HISTORIC AND DESIGN REVIEW COMMISSION

March 16, 2022

HDRC CASE NO: 2022-148
ADDRESS: 624 E MYRTLE
LEGAL DESCRIPTION: NCB 1754 BLK 3 LOT 6
ZONING: R-6, H
CITY COUNCIL DIST.: 1
DISTRICT: Tobin Hill Historic District
APPLICANT: Davis Sprinkle/Sprinkle & Co Architects, LLC
OWNER: William Leighton/LEIGHTON WILLIAM F
TYPE OF WORK: Construction of a 2-story rear accessory structure
APPLICATION RECEIVED: February 24, 2022
60-DAY REVIEW: Not applicable due to City Council Emergency Orders
CASE MANAGER: Claudia Espinosa

NORTH ELEVATION
624 E. MYRTLE 1/8" = 1'-0"

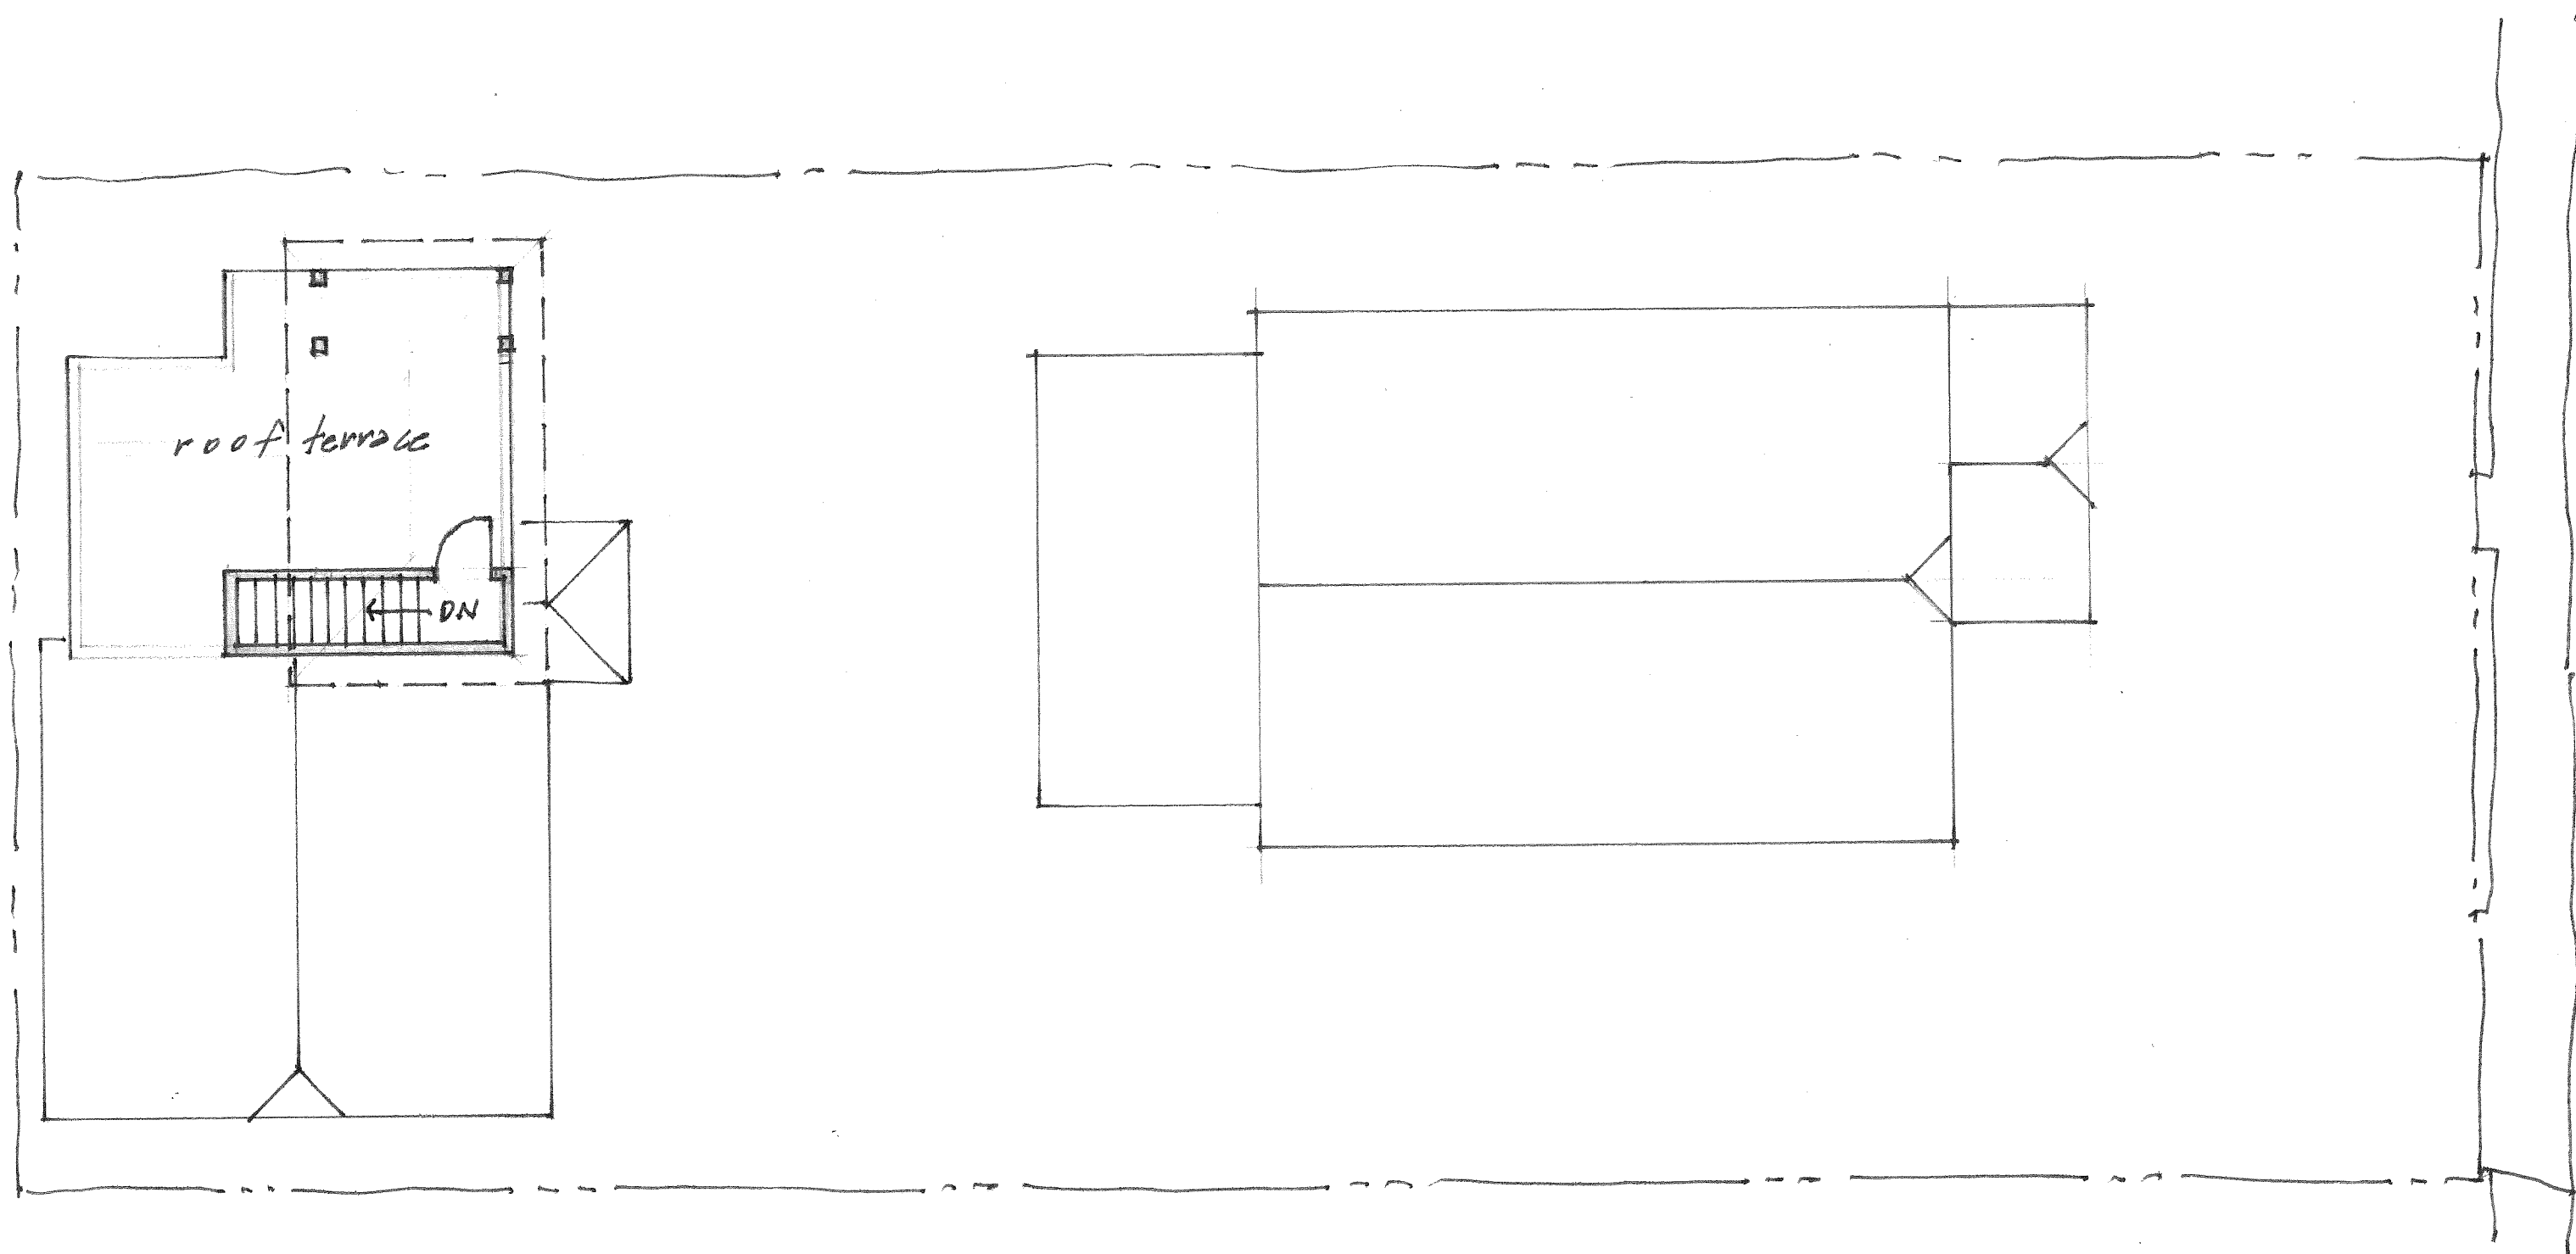
- f. **ADDITION (Architectural Details)** – The applicant has proposed for the proposed addition to feature a flat roof. As noted in finding d, staff finds that a roof form that is consistent with the clipped gabled and gabled roofs found historically on the site would be most appropriate.

- g. **ADDITION (Fenestration Profile)** – The applicant has proposed for the addition to feature Chicago Style windows. The Guidelines for Additions 4.A.ii. notes that architectural details that are in keeping with those of the original should be used. Staff finds this fenestration profile to be inconsistent with that of the historic structure. Staff finds that windows should feature a one over one profile, consistent with those found historically on the primary structure.

- i. That siding and framing materials be salvaged from the existing, rear structure and be incorporated in to the proposed new construction.
- ii. That the proposed roof form be modified to feature a gabled roof form to be consistent with the existing roof forms on site as noted in findings e and f. This may require the elimination of the rooftop deck and tower element.
- iii. That the applicant incorporate window profiles that are consistent with those found historically on the primary historic structure. The proposed Chicago style windows are not consistent with the Guidelines.
- iv. That the proposed wood windows be consistent with staff's standards for windows in additions and new construction.
